# Alexandra Basin Redevelopment Project

ABR Project Response to RFI RPS

Dublin Port Company (DPC) submitted a planning application for the Alexandra Basin Redevelopment Project to An Bord Pleanála in March 2014 under planning reference number 29N.PA0034.

On 7<sup>th</sup> July, An Bord Pleanála issued by letter a request for further information (RFI), 29N.PA0034 with a request that the information should be submitted to the Board by 18<sup>th</sup> August 2014.

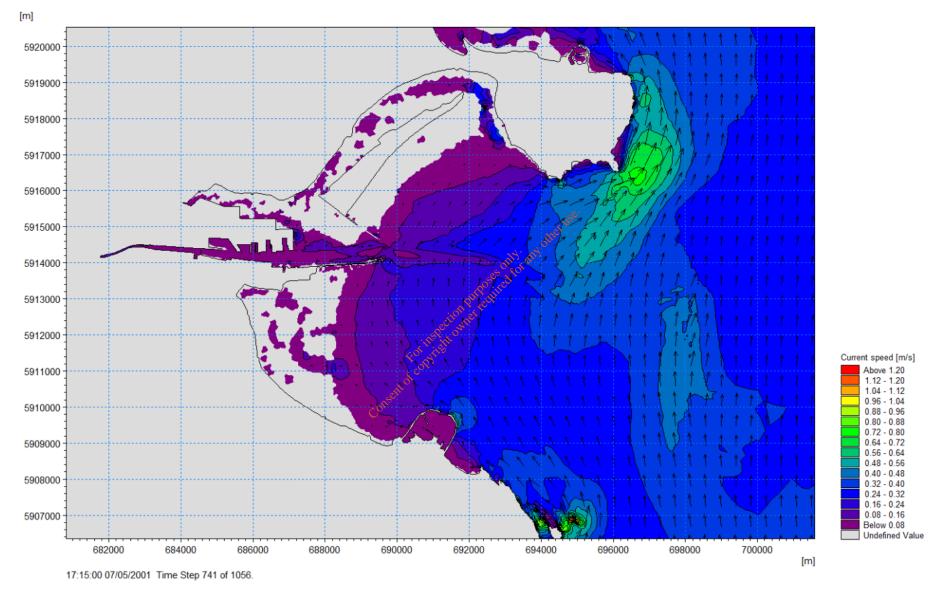
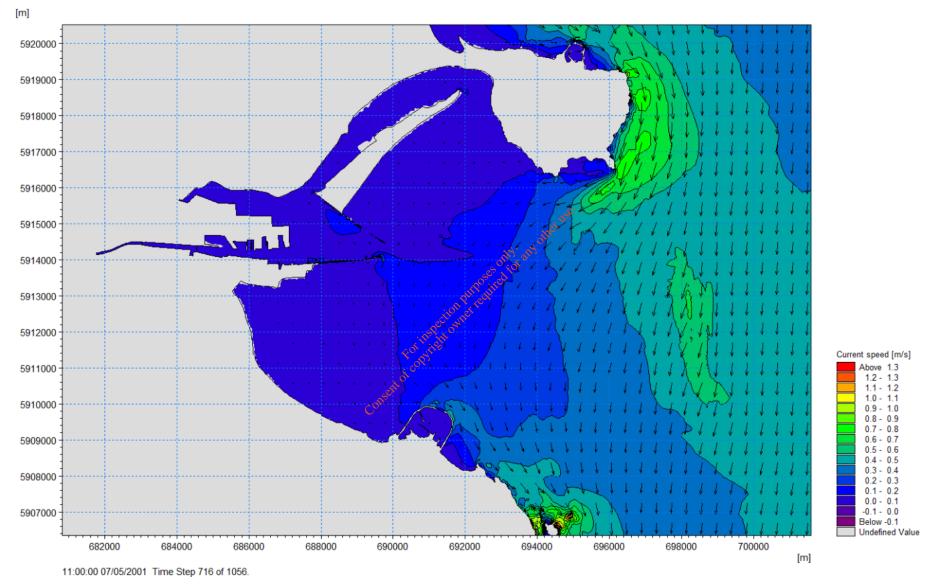
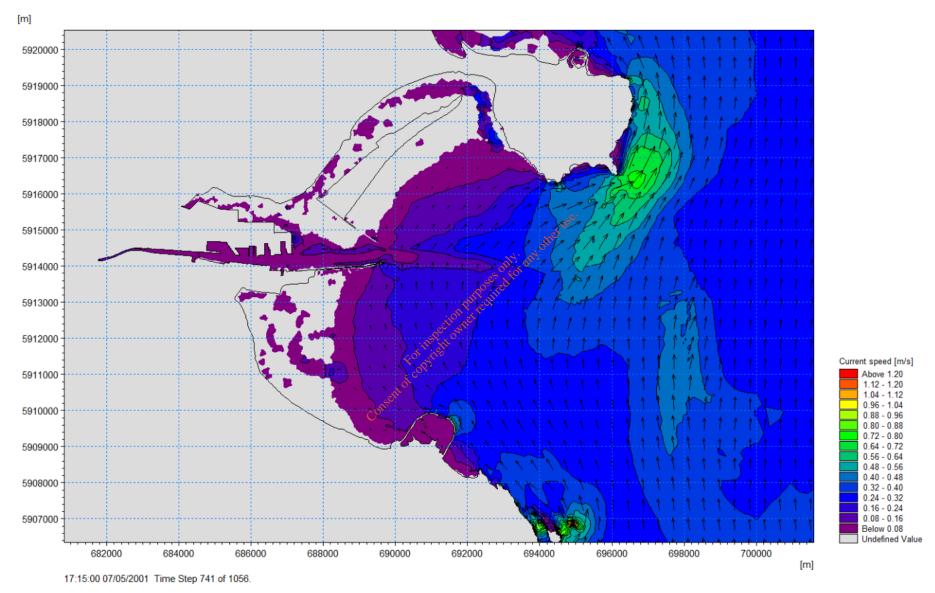
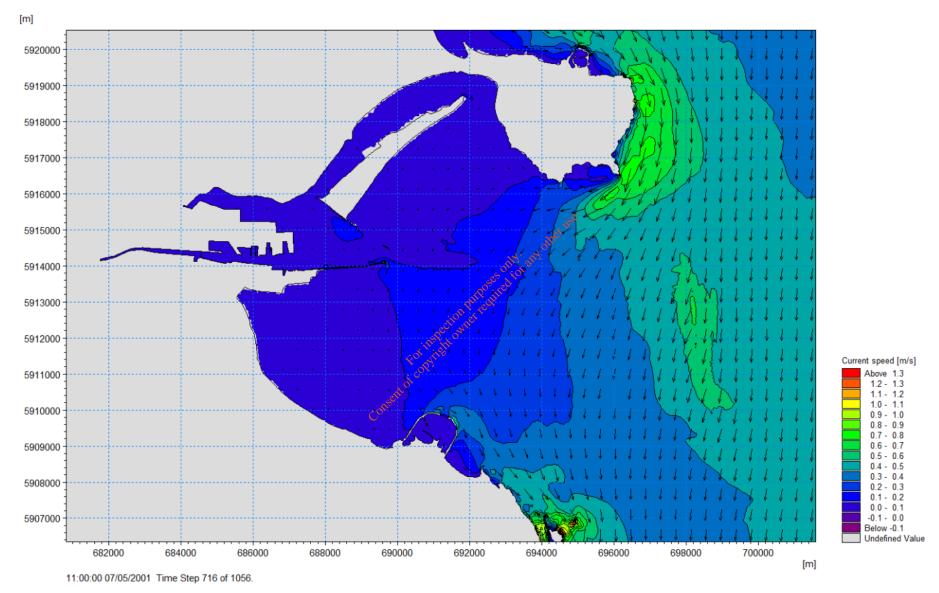
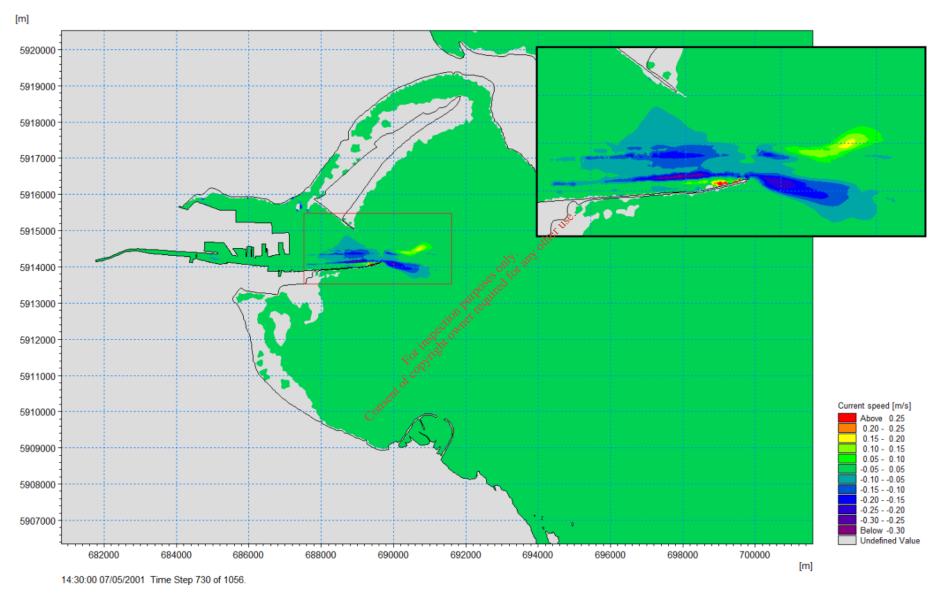
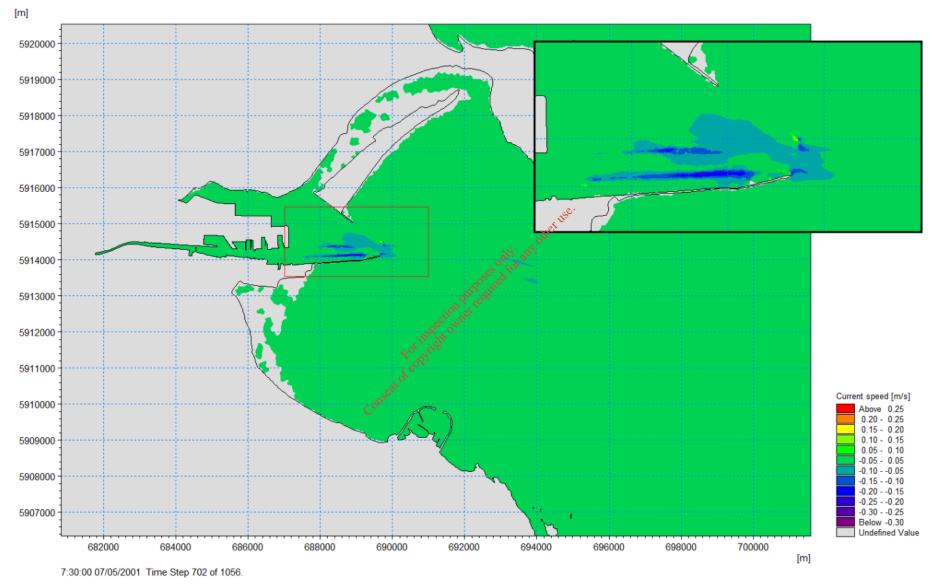
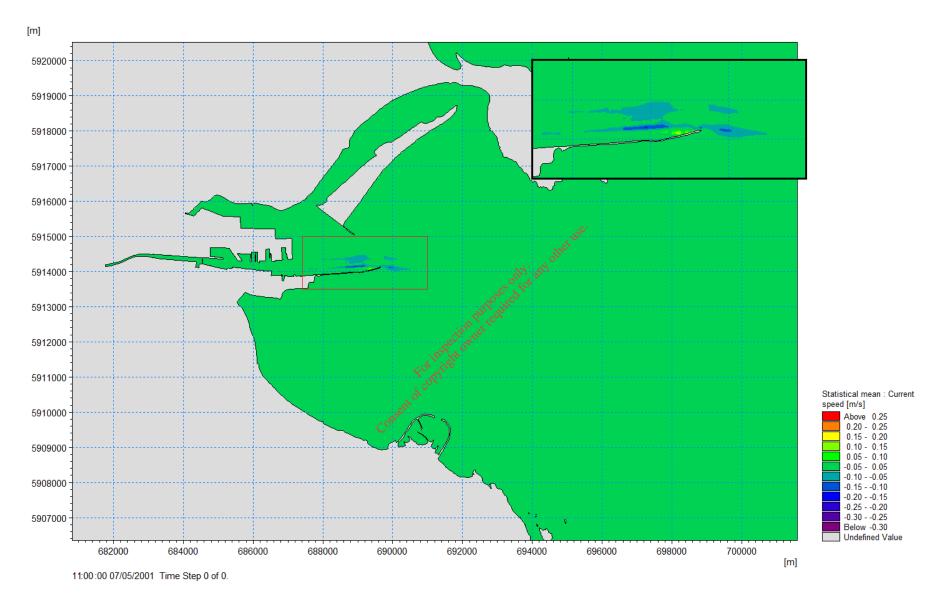
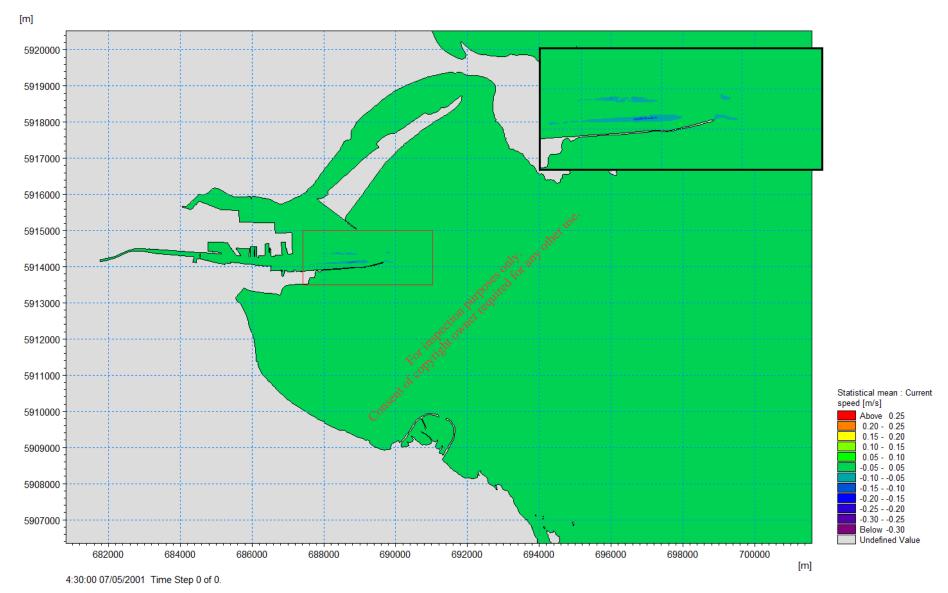
8.3 There is a high reliance on relatively poor resolution colour contour/tonal plots to demonstrate magnitude of impact in the EIS (for example Figure 9.7 to 9.23). Provide zoomed in plots in addition to time series plots at relevant reference locations and also where appropriate provide tabular comparisons.

All plots presented in this section have been made digitally available in a separate PDF document.
